Landmark Commission
Planning & Development Division
City of Galveston
August 3, 2020

20LC-058 STAFF REPORT

ADDRESS:
1118 Sealy / Avenue I

REQUEST:
Request for a Certificate of Appropriateness for alterations to the structure including modifications of the rear façade of the house, the accessory structure, and the addition of a metal shingle roofing.

Comparisons of Sanborn Map footprints for 1118 Sealy

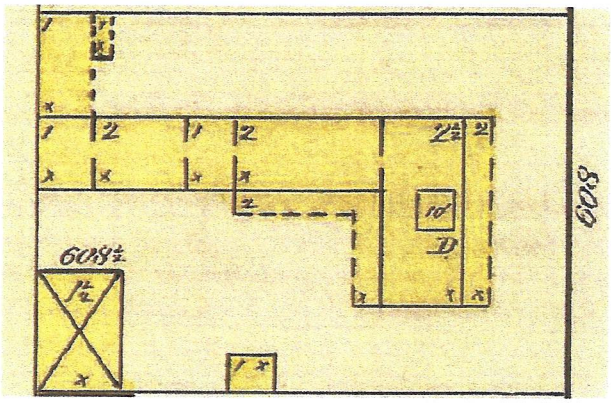
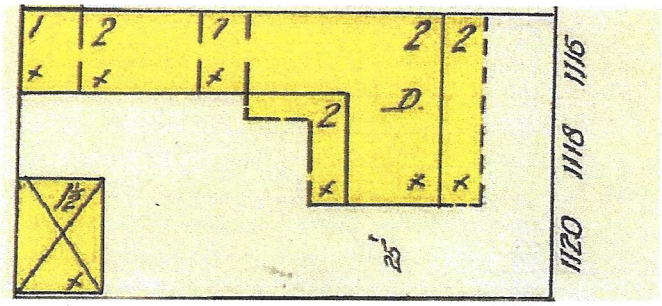
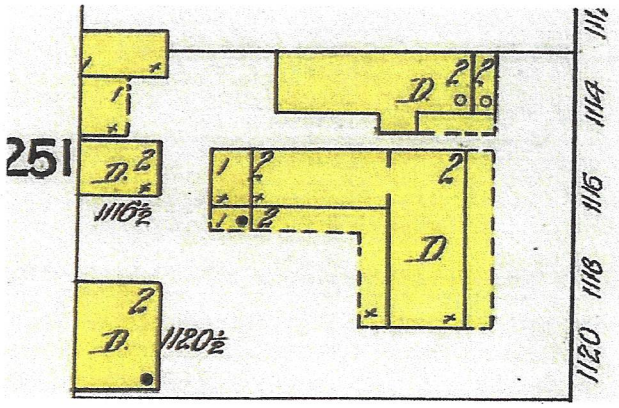
- The applicant submitted a Sanborn Map from 1889 showing the cupola on the roof of the structure. According to the applicant, there was some structural evidence of the existence of the cupola on the roof.
- Rebuild the Cupola in previous footprint. Cupola will have a total of 12 wood windows with three per side that are in a four over one light configuration. Decorative panels on the bottom with composition shingles to match the existing roof with clerestory windows below the decorative panels. Dentil molding and decorative columns on either side of the windows.

2 4- Cupola New/Proposed.
1/4" = 1'-0"

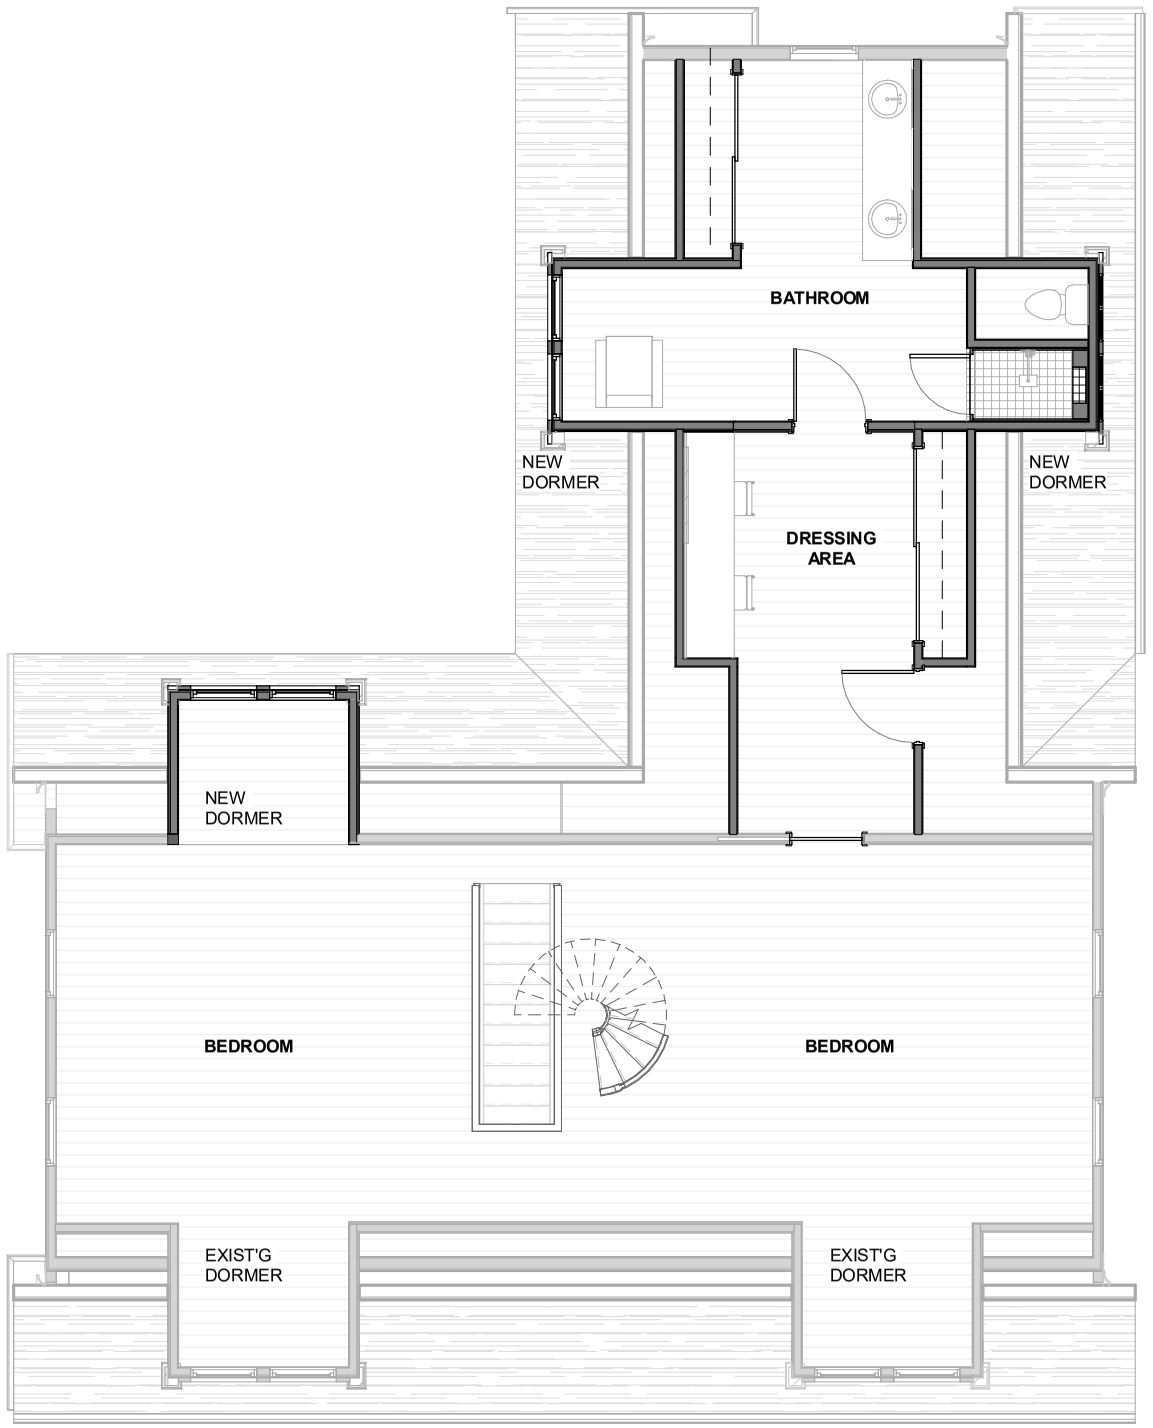
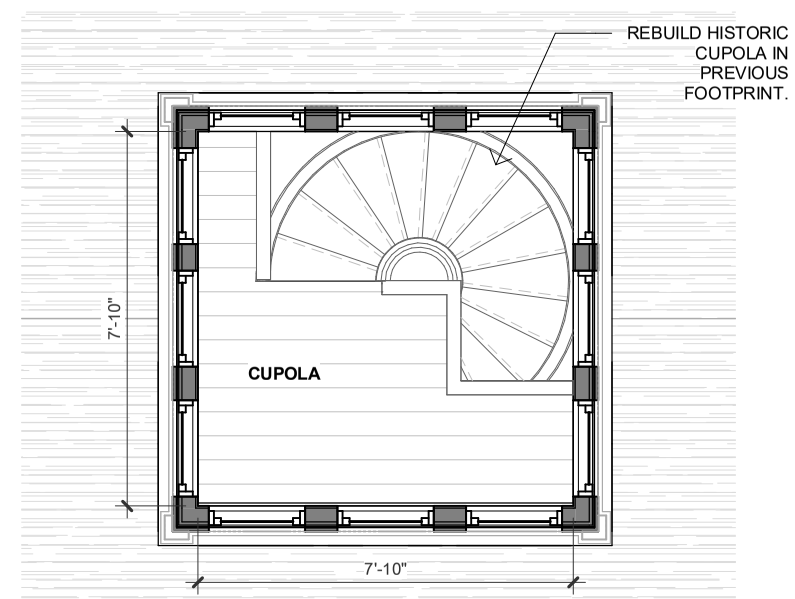
Part of the cupola is located in Location A: Primary Façade, preservation and repair of features in place is the priority. This is especially important at the street level and in locations where the feature is highly visible. The applicant stated that the cupola is being rebuilt, but there is no evidence of what the original cupola looked like. Staff finds that since there is no evidence of what the cupola looked like the design should be simple to avoid creating a false sense of history. The decorative panels, clerestory windows and dentil molding should be omitted since the cupola is highly visible.

1. The applicant shall conform to the design, material, and placement shown in Attachment A of the staff report with the following modifications:
    a. The dentil molding, decorative panels and clear story windows shall be omitted from the cupola design;

1 East
1/8" = 1'-0"

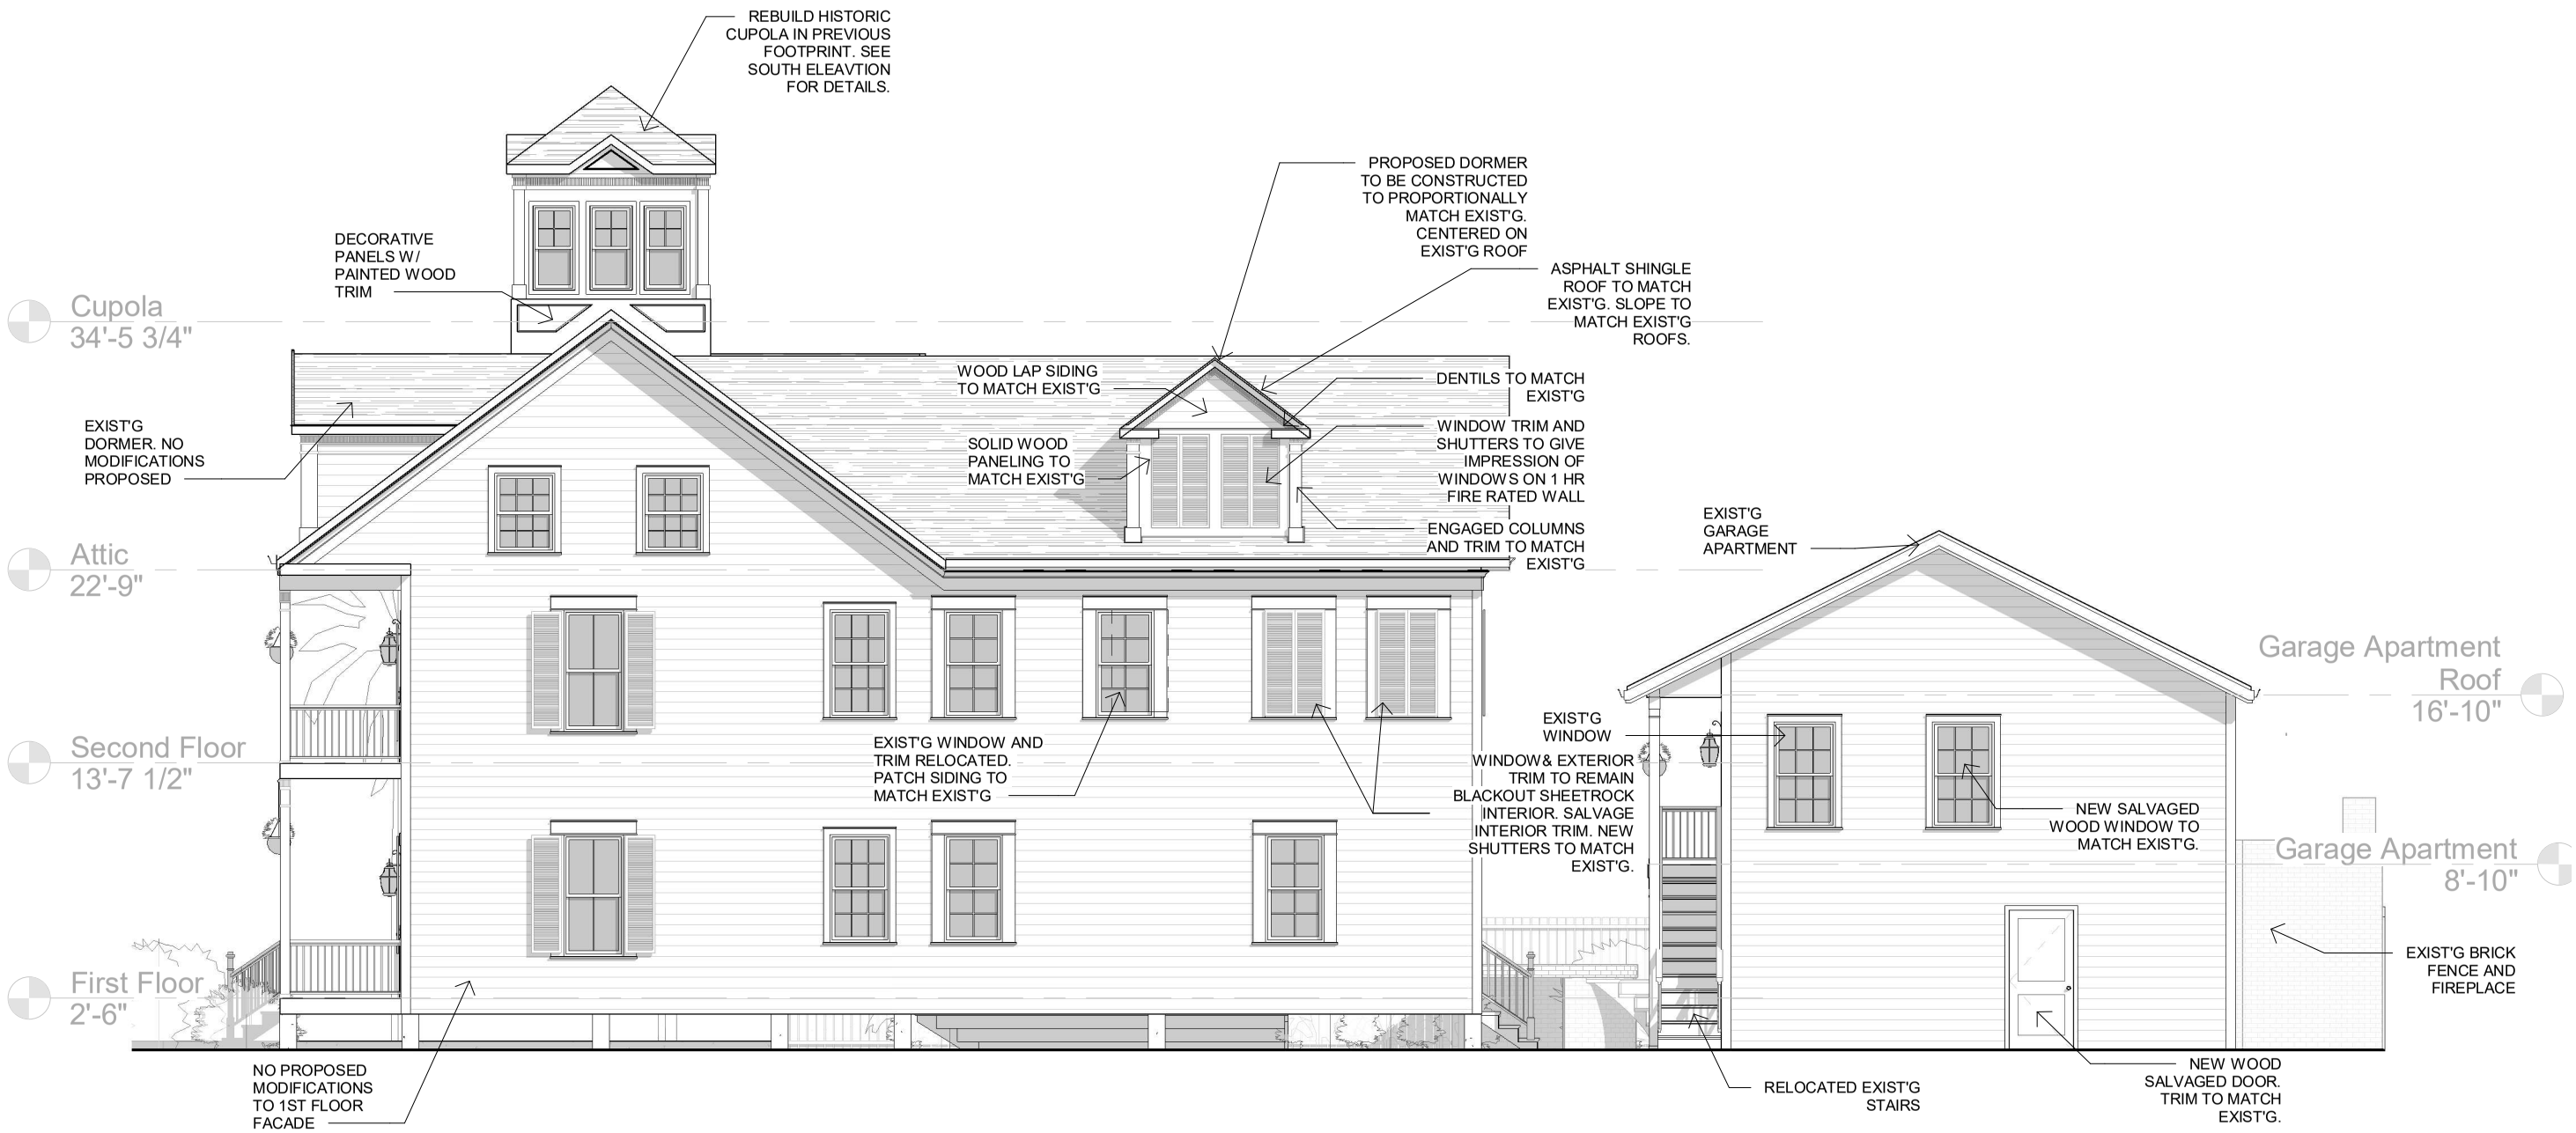
Location C: Less Visible Secondary Wall: Preservation is still preferred but additional flexibility exists for compatible replacement or alteration. Primary Façades are the priority. There are three windows being permanently closed with shutters. The window trim will remain on the exterior to give the impression of a window. The new dormer will also be permanently closed with shutters on this façade. Staff finds the proposed modifications conform to the Design Standards, since they are located in Location C: Less visible secondary wall.

1 North
1/8" = 1'-0"

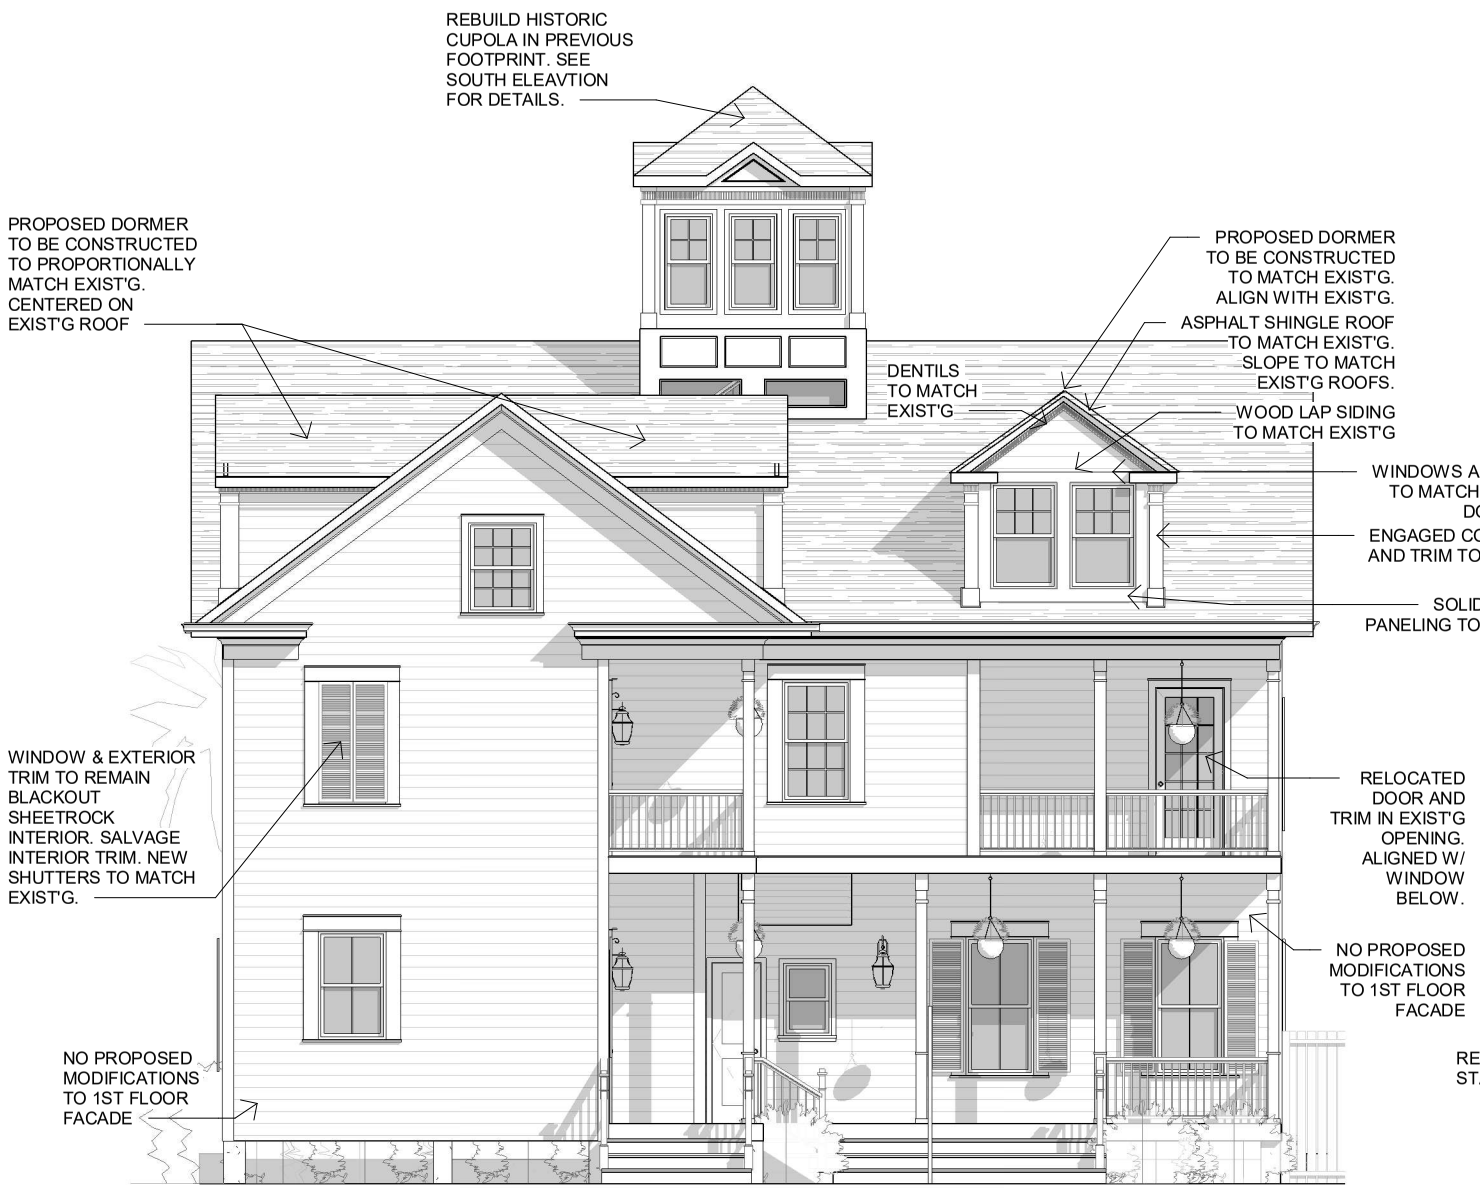
Location D: Not Typically Visible Rear Façade: More flexibility in treatment may be considered, especially for compatible replacement or alteration that is not visible from the street. There is one dormer on this façade with windows to match the front dormers. A door will be relocated to this north façade in alignment with the downstairs window. The door is relocated from the west side of the upper back porch. Staff finds the modifications in this location to be in conformance with the Design Standards since they are in location D.

1 West
1/8" = 1'-0"

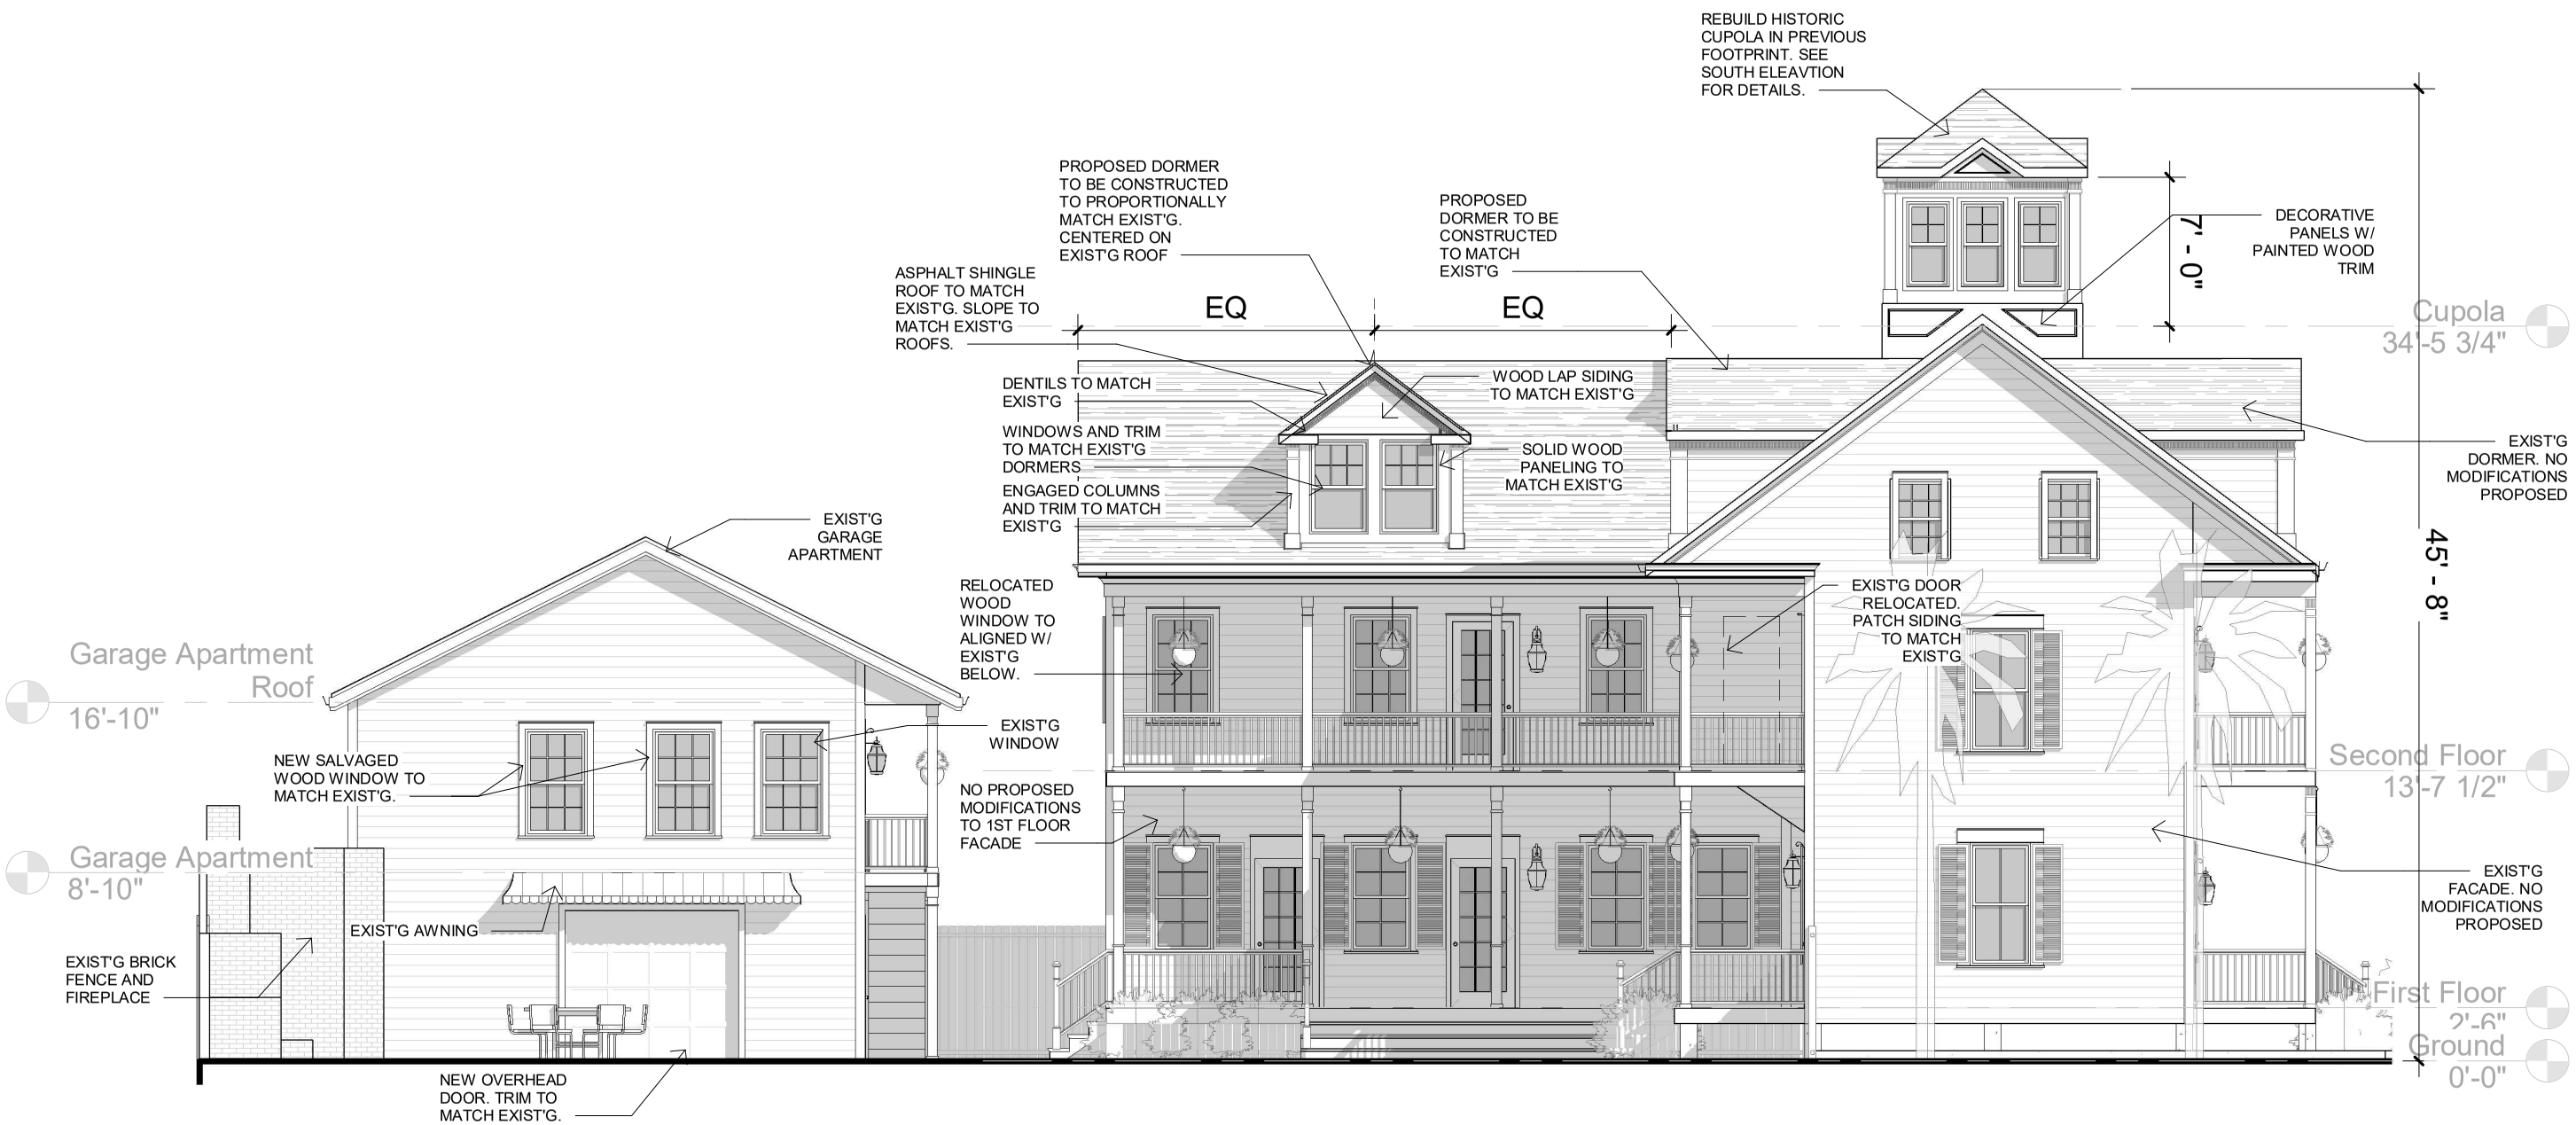
Location D. Not Typically Visible Rear Façade. More flexibility in treatment may be considered, especially for compatible replacement or alteration that is not visible from the street. The west façade is in Location D on the rear of the structure but this side faces west in the interior of the lot. A door opening will be closed and siding to match the house will be added to cover the opening. A window is being installed on the second floor in alignment with the downstairs window. There is more flexibility in this location. Staff finds enclosing of a door opening and the installation of a wood window and a new dormer to be in conformance with the Design Standards in this location.
